# CITY OF ALBUQUERQUE

**Re: VENTANA SQUARE GIANT CONVENIENCE STORE, LOT H-1**  
**6570 Paradise Blvd. NE**  
**Approval of Permanent Certificate of Occupancy (C.O.)**  
**Engineer's Stamp dated 05/08/2006 (B-10/D8D)**  
**Certification dated 10/05/2006**

Drainage and  
Grading Plan

C-1  
SHEET

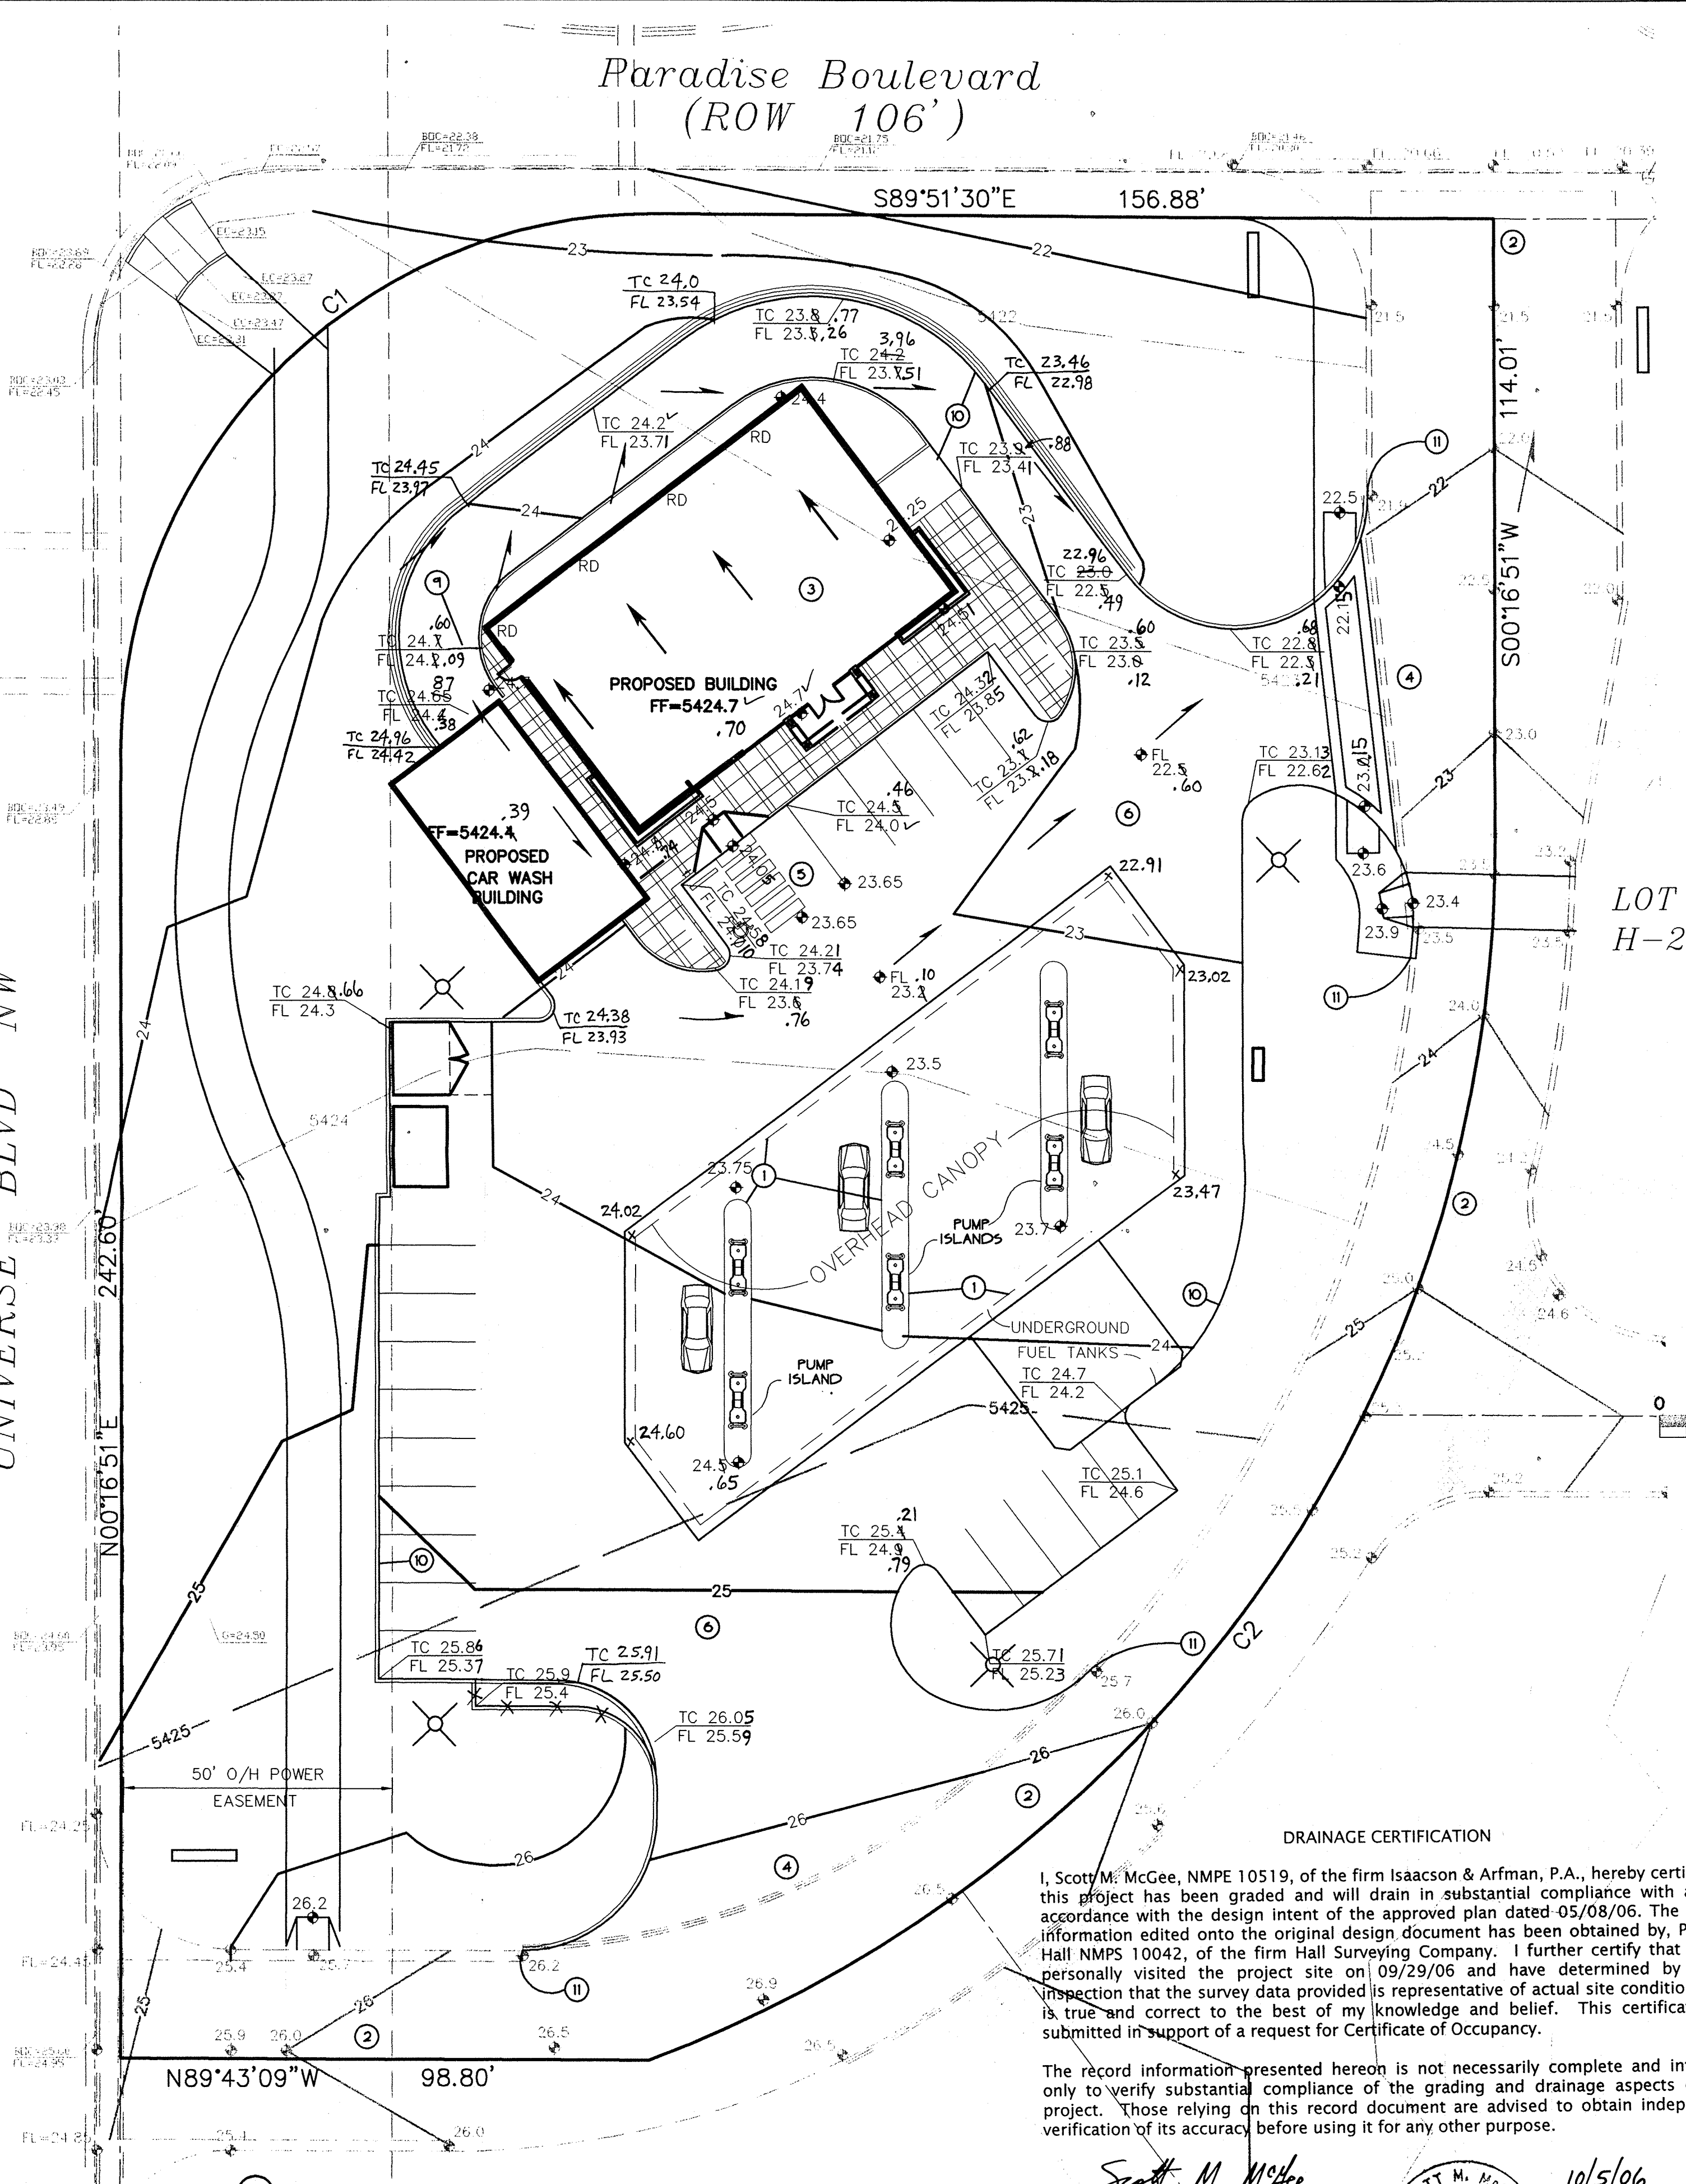
Based upon the information provided in your submittal received 10/05/2006, the above referenced certification is approved for release of Permanent Certificate of Occupancy by Hydrology.
